March 28, 2014
Subject: **Augusta Phase 2**
State Project No: 020118.20
Amendment No. 2

Make the following change to the Bid Documents:

SECTION DETAIL - NOTE CLARIFICATION

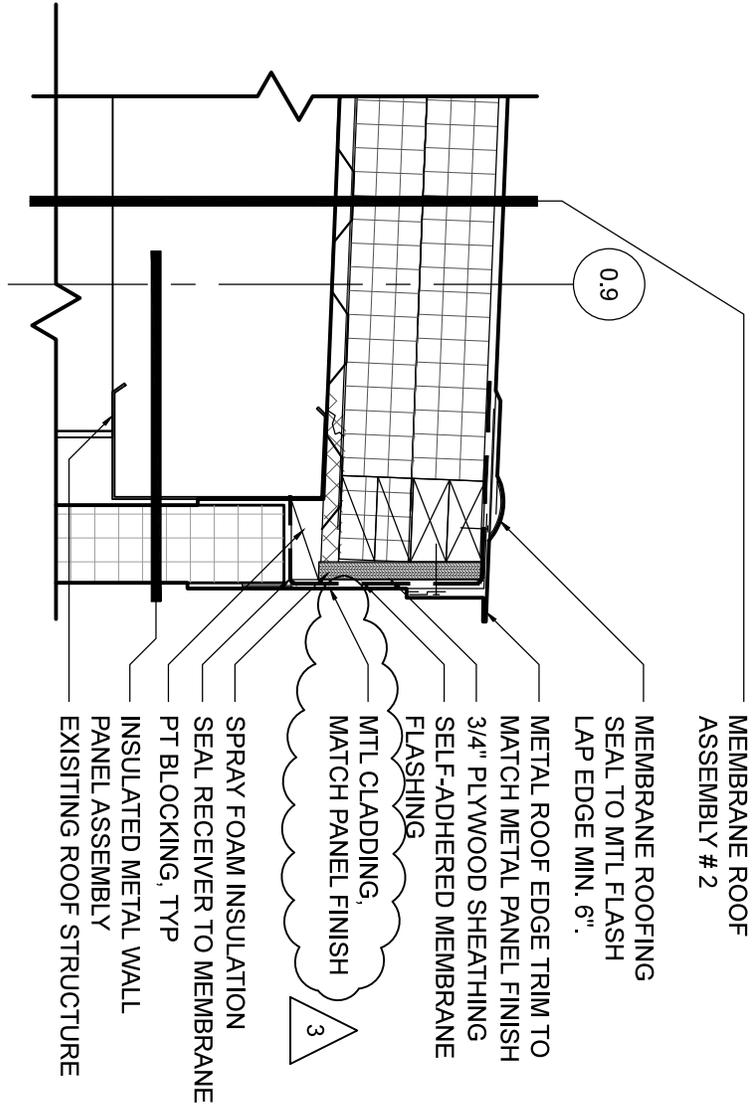
On plan sheet A411 **DELETE** Drawing 5 Section Detail and **ADD** Drawing 5 Section Detail per SKA-22 SECTION DETAIL- NOTE CLARIFICATION in its place.

9 Section Detail

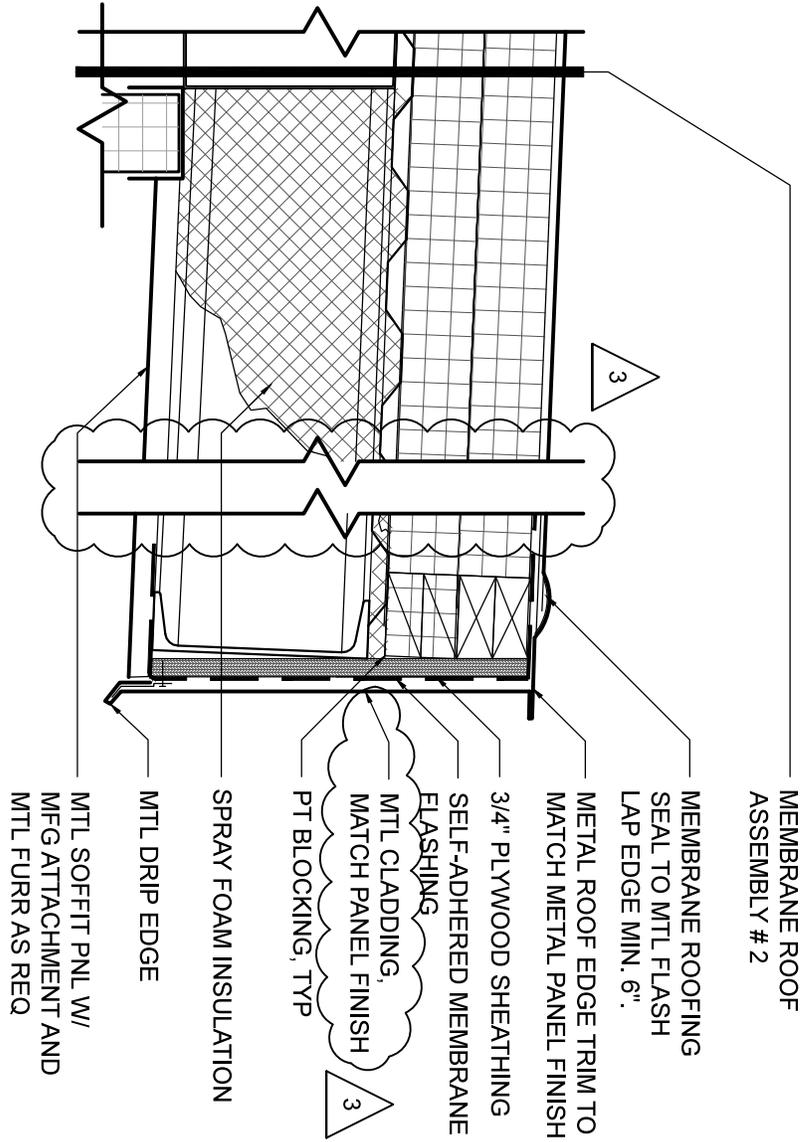
On plan sheet A411 **DELETE** Drawing 9 Section Detail and **ADD** Drawing 9 Section Detail per SKA-23 SECTION DETAIL- NOTE CLARIFICATION in its place.

Question: How large is the overhang on detail 9 of sheet A411?

Response: Per Sheet A103 Architectural roof plan 4’-1” from the face of the siding.

13
A411 **Roof Curb, Typical**
SCALE: 1 1/2" = 1'-0"

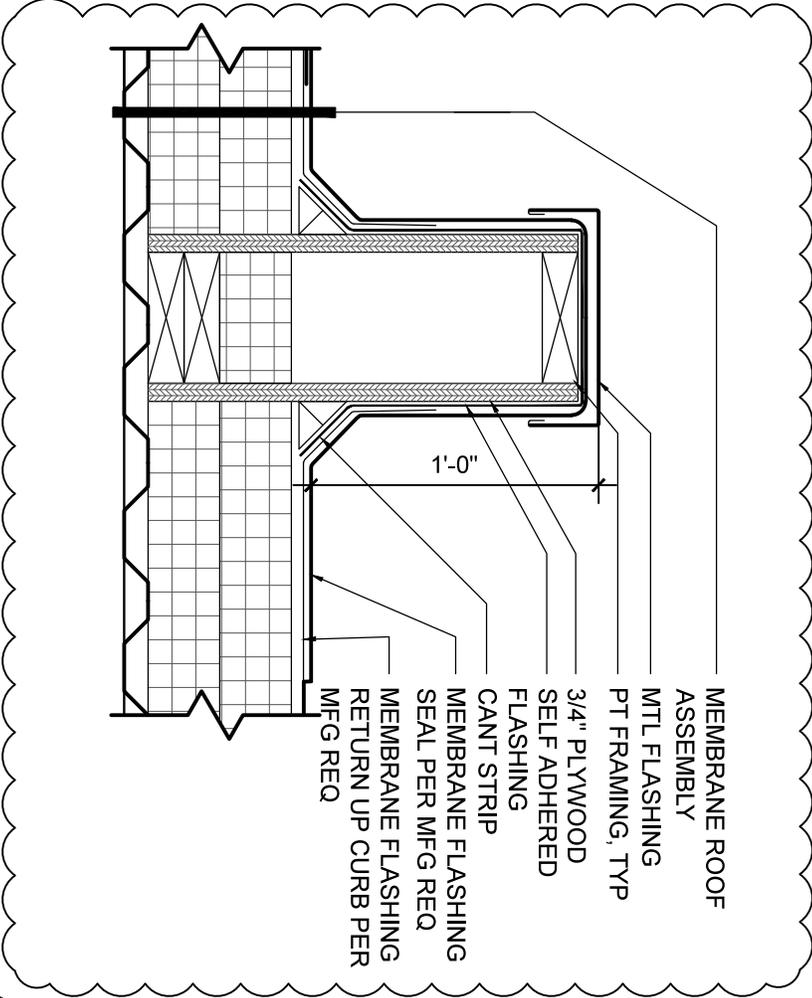
On plan sheet A411 **ADD** Drawing 13 Typical Section Detail per SKA-24 TYPICAL SECTION DETAIL- ROOF CURB

TYPICAL SECTION DETAIL - ROOF PENETRATION - SEE 17-A411	
66 INDUSTRIAL DRIVE - PHASE 2 66 INDUSTRIAL DRIVE, AUGUSTA, MAINE MAINE DEPARTMENT OF TRANSPORTATION	
SCALE: AS NOTED	PROJ NO: 13057
DATE: 03/28/2014	CAD FILE: A411.DWG

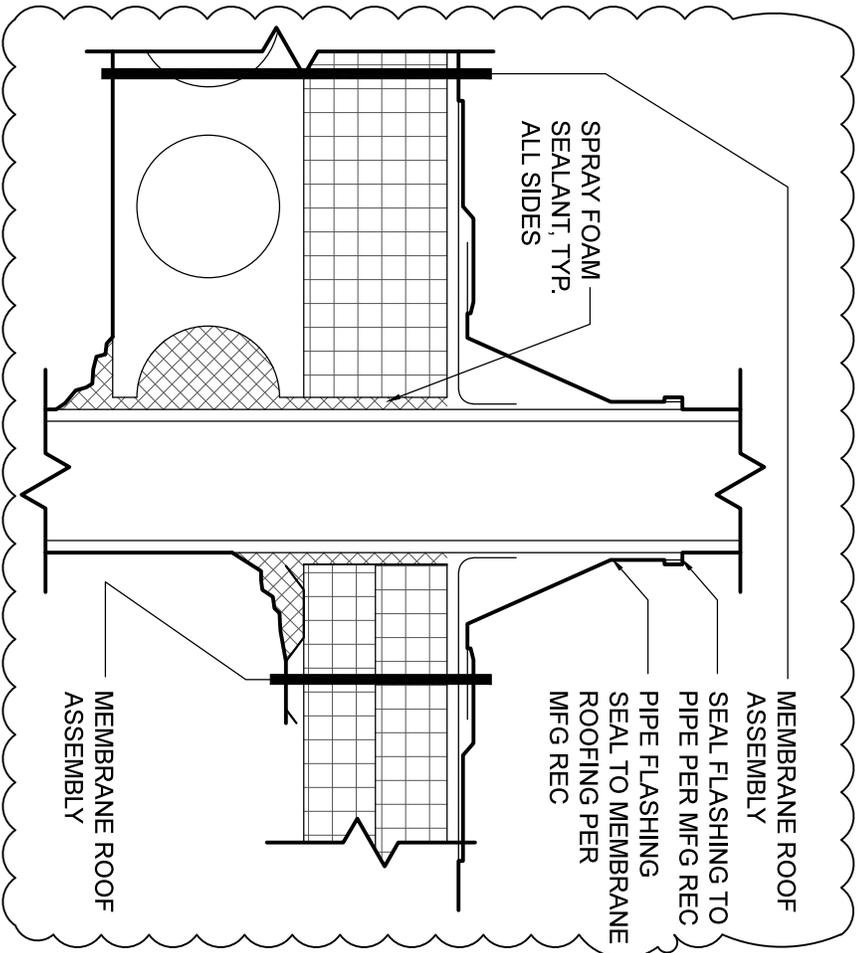
On plan sheet A411 **ADD** Drawing 17 Typical Section Detail per SKA-25 TYPICAL SECTION DETAIL- ROOF PENETRATION

18
 A411 Section Detail
 SCALE: 1 1/2" = 1'-0"

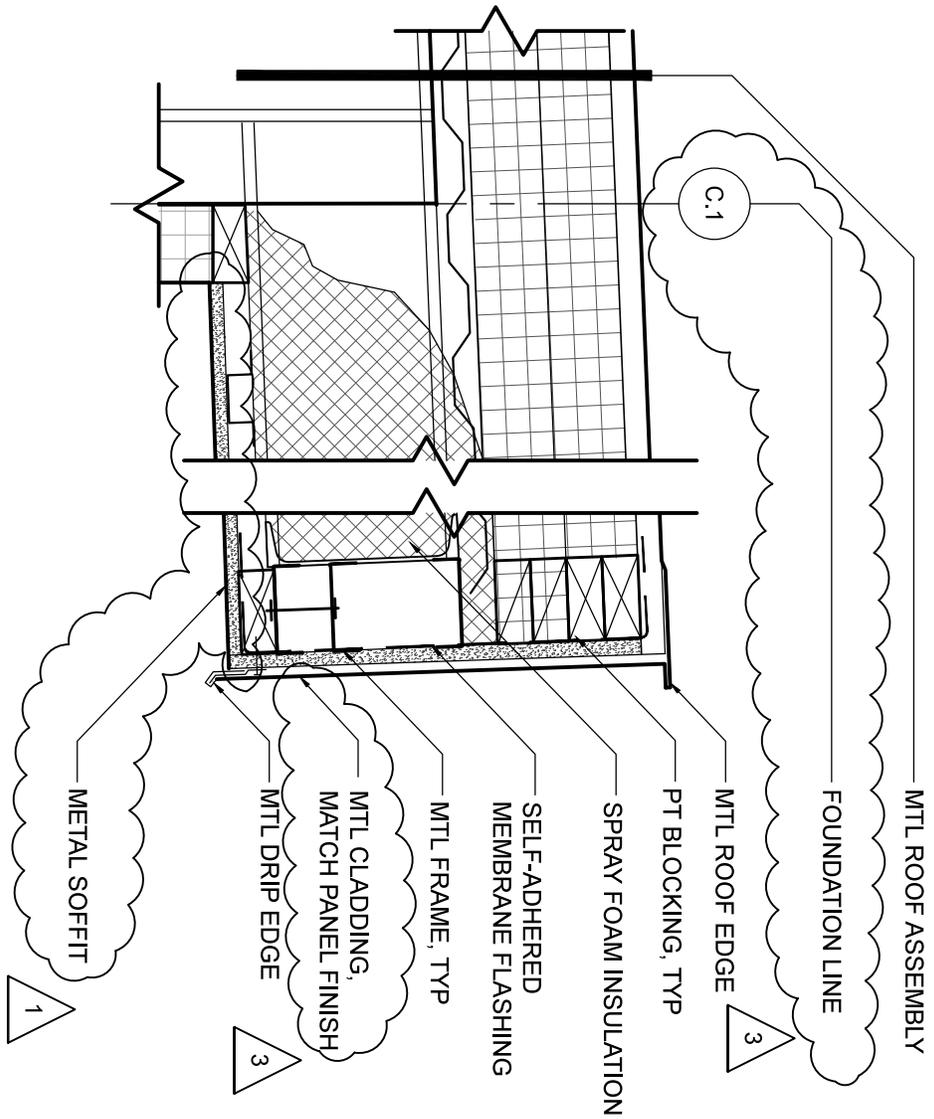
On plan sheet A411 **DELETE** Drawing 18 Section Detail and **ADD** Drawing 18 Section Detail per SKA-26 SECTION DETAIL- NOTE CLARIFICATION in its place.

19 Section Detail
 A411 SCALE: 1 1/2" = 1'-0"

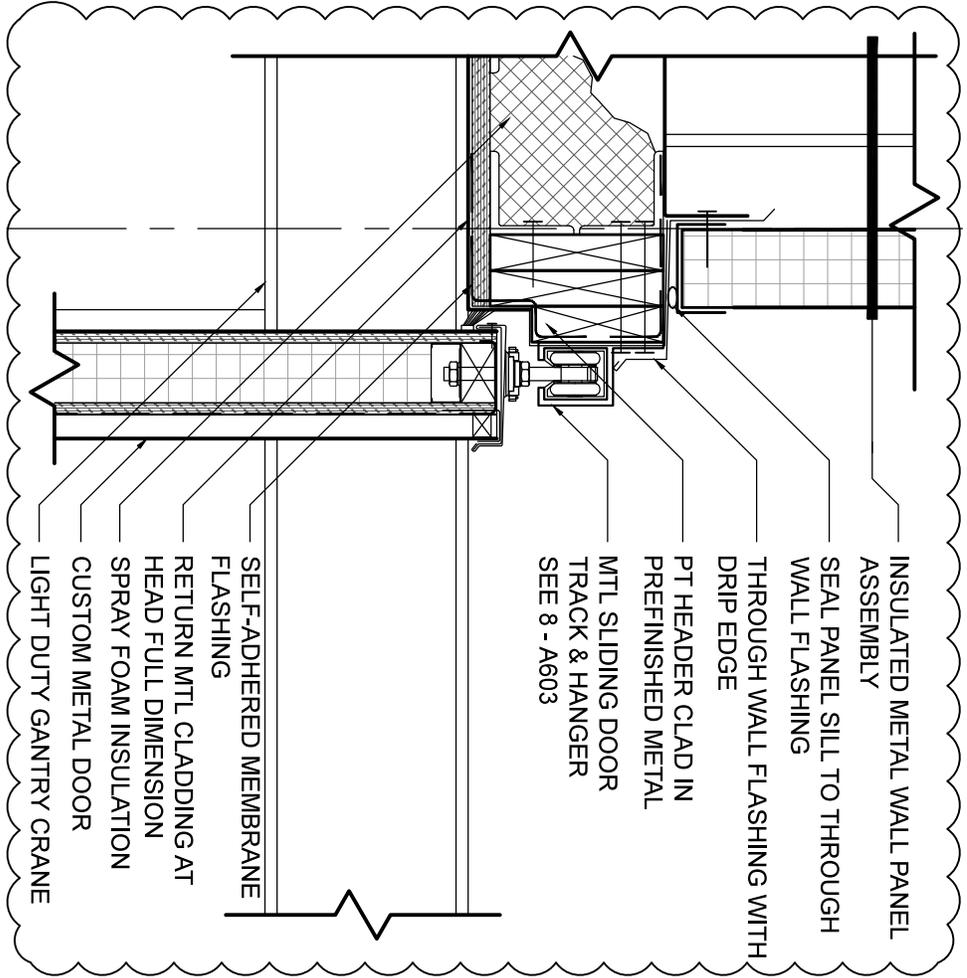
On plan sheet A411 **DELETE** Drawing 19 Section Detail and **ADD** Drawing 19 Section Detail per SKA-27 SECTION DETAIL- STRUCTURAL COORDINATION in its place.

20
 A411
Section Detail
 SCALE: 1 1/2" = 1'-0"

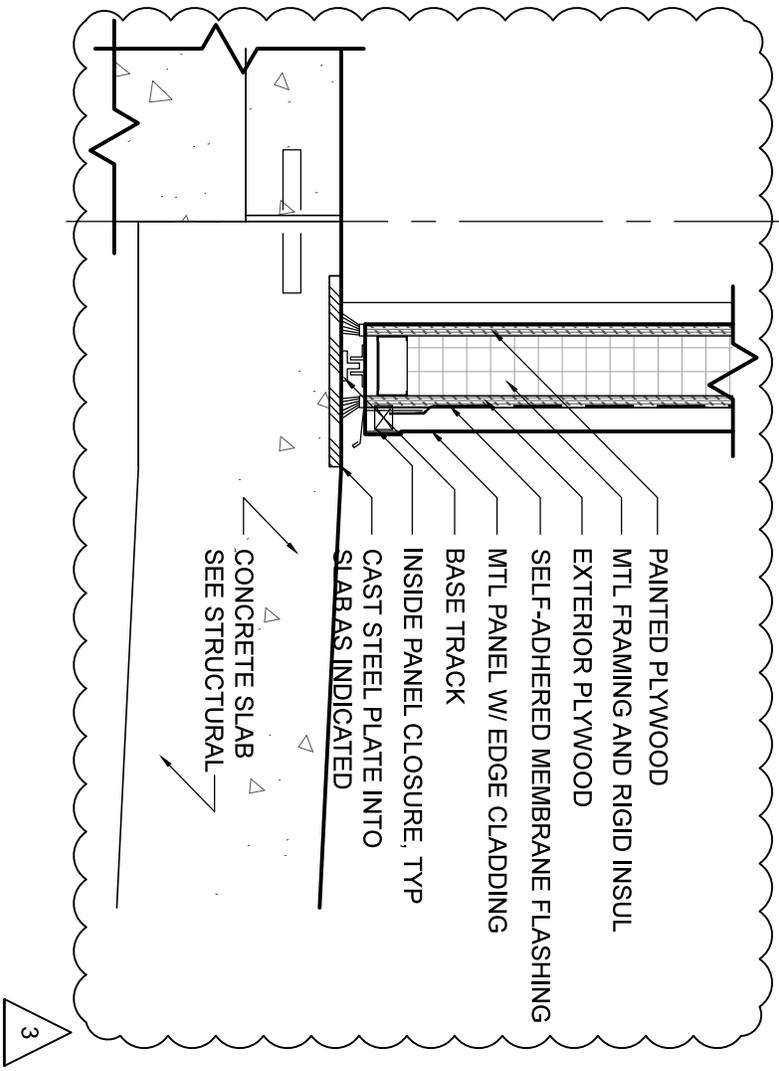
On plan sheet A411 **DELETE** Drawing 20 Section Detail and **ADD** Drawing 20 Section Detail per SKA-28 SECTION DETAIL- STRUCTURAL COORDINATION in its place.

1 Section Detail
 A412 SCALE: 1 1/2" = 1'-0"

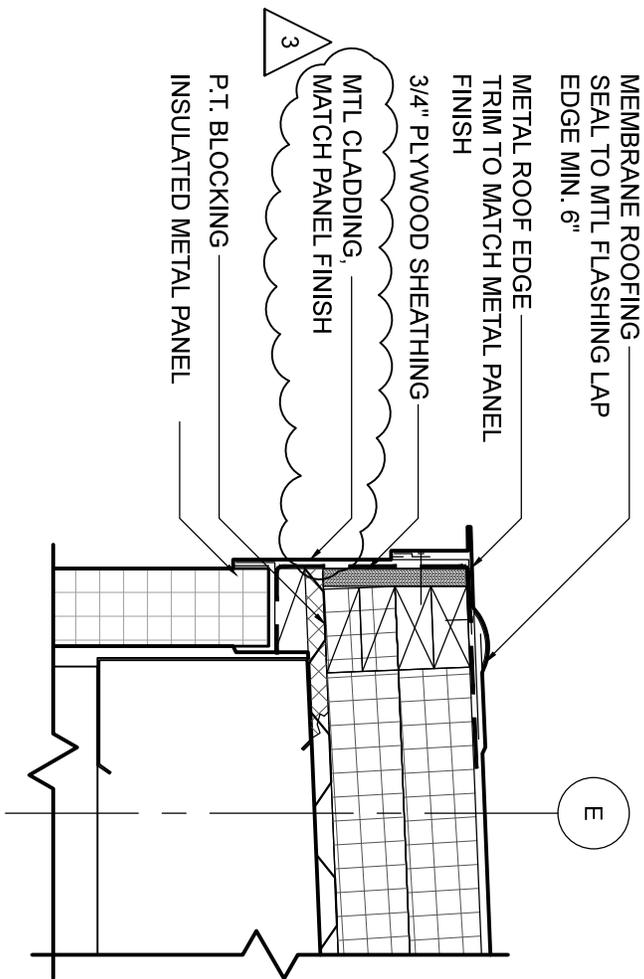
On plan sheet A412 **DELETE** Drawing 1 Section Detail and **ADD** Drawing 1 Section Detail per SKA-29 SECTION DETAIL- NOTE CLARIFICATION in its place.

5
Section Detail
A412 SCALE: 1 1/2" = 1'-0"

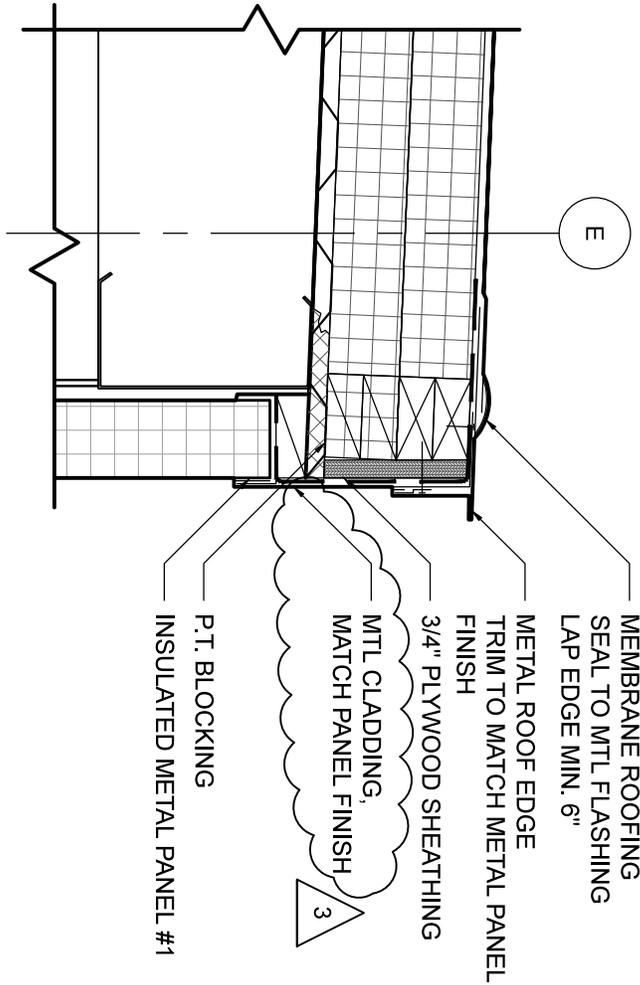
On plan sheet A412 **DELETE** Drawing 5 Section Detail and **ADD** Drawing 5 Section Detail per SKA-30 SECTION DETAIL- NOTE CLARIFICATION in its place.

9
 A412
Section Detail
 SCALE: 1 1/2" = 1'-0"

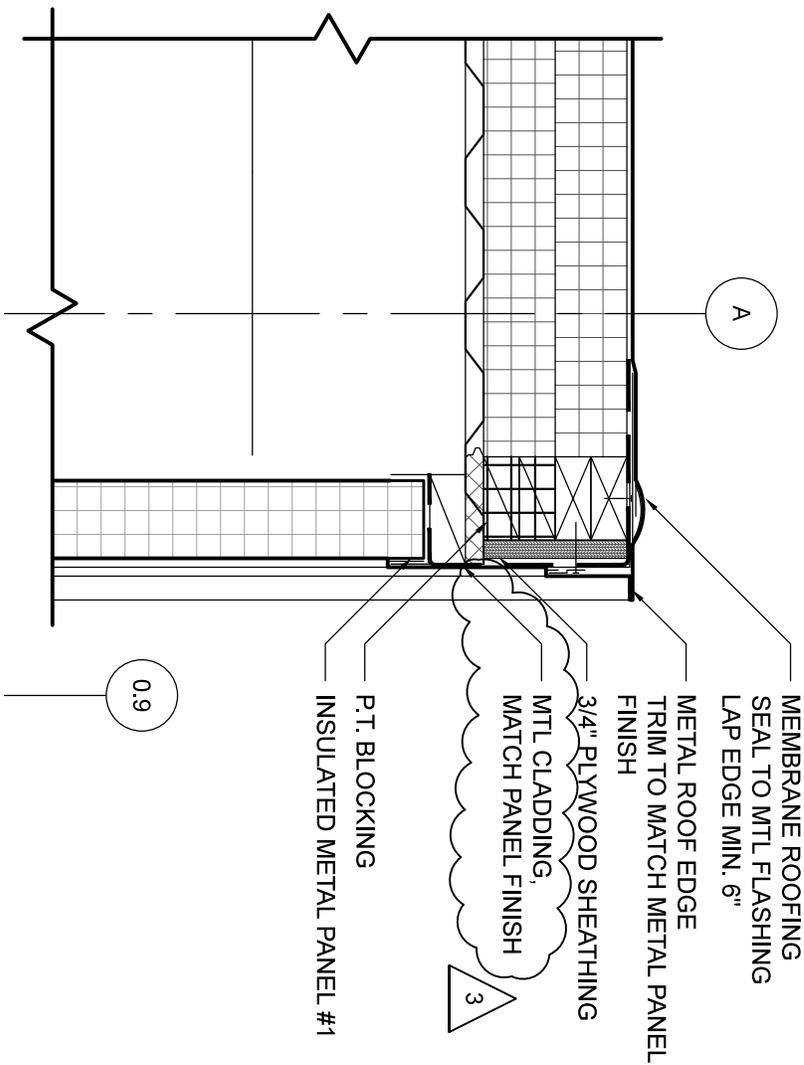
On plan sheet A412 **DELETE** Drawing 9 Section Detail and **ADD** Drawing 9 Section Detail per SKA-31 SECTION DETAIL- NOTE CLARIFICATION in its place.

6
A603

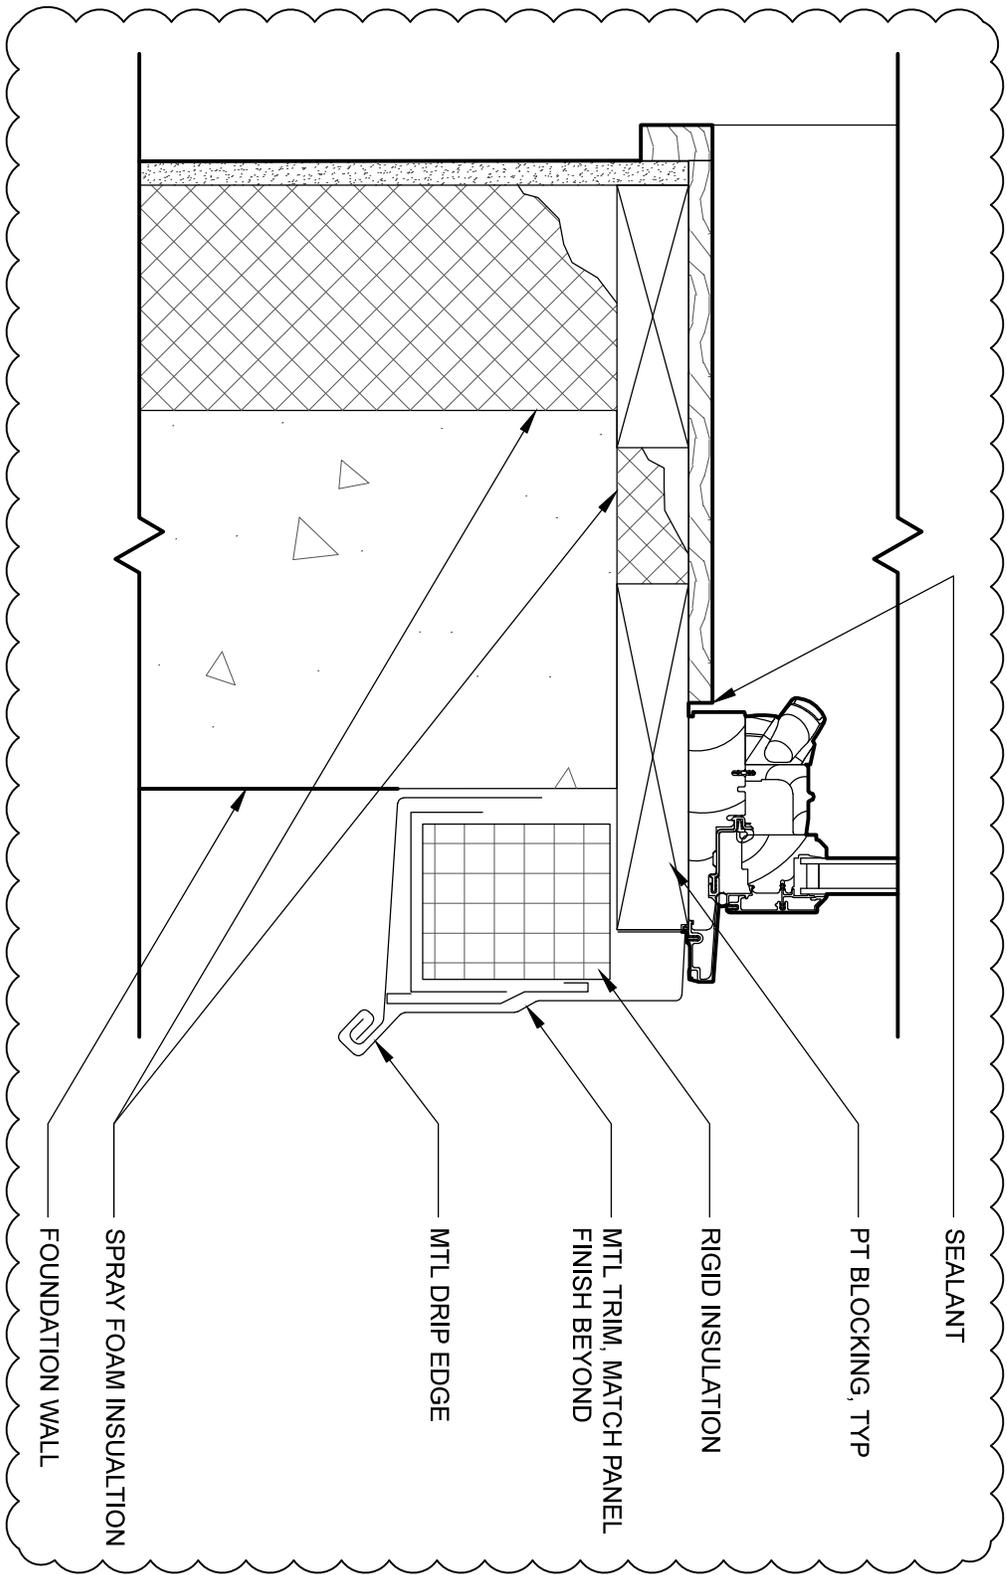
On plan sheet A603 **DELETE** Drawing 6 Detail- Not Used and **ADD** Drawing 6 Sill Detail per SKA-33 WINDOW SILL DETAIL.
